UNITED STATES DEPARTMENT OF COMMERCE
National Institute of Standards and Technology
Gaithersburg, Maryland 20899

Subject: Response to NRC, Request for Additional Information (RAI), dated 6/27/07

Docket Number: 50-184

NIST Response to Second Round of NRC
Request for Additional Information
Dated 6/27/07

Figure 2.3.1-3a ASCE 7-93 50-Year Wind Zones

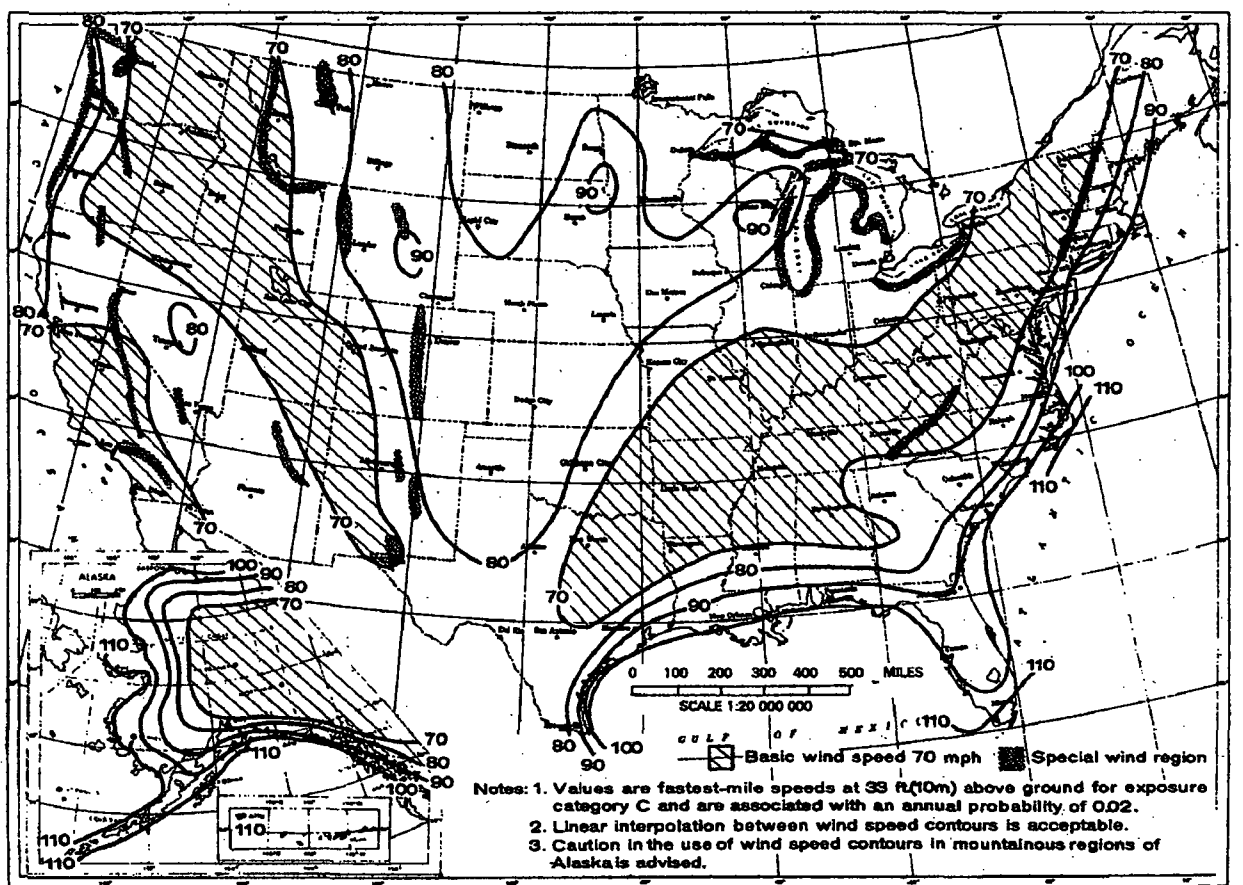
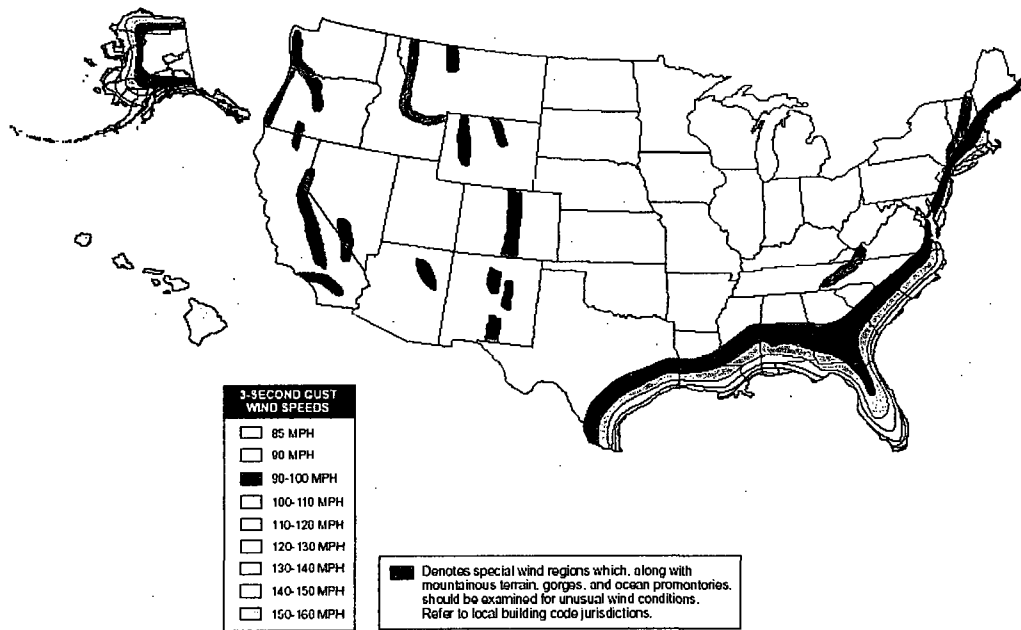
For reference, Figure 2.3.1-3a illustrates the ASCE fastest mile and 50-year return wind zones for Central Maryland as 70 mph. Figure 2.3.1-3b illustrates the ASCE 7-98 3-second peak gust and 50-year return wind zones Central Maryland as 90 mph.

Figure 4.2.3: Fuel Element Assembly (see Figure 4.2.4 for Fuel Plate Detail)

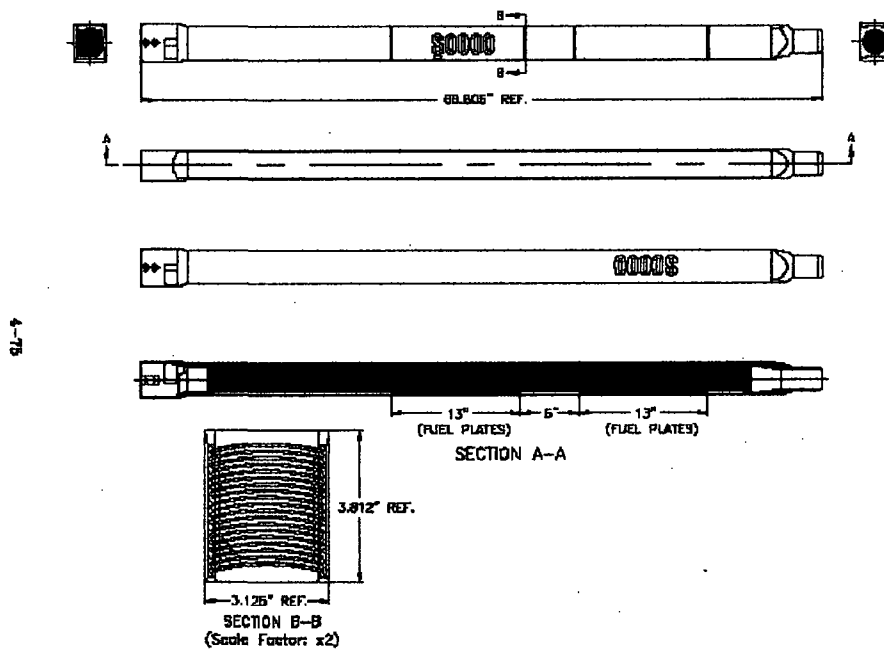
4.2 Provide revised Figures 4.2.3 and 4.2.4, which were not attached to the response.

NIST Response to 4.2
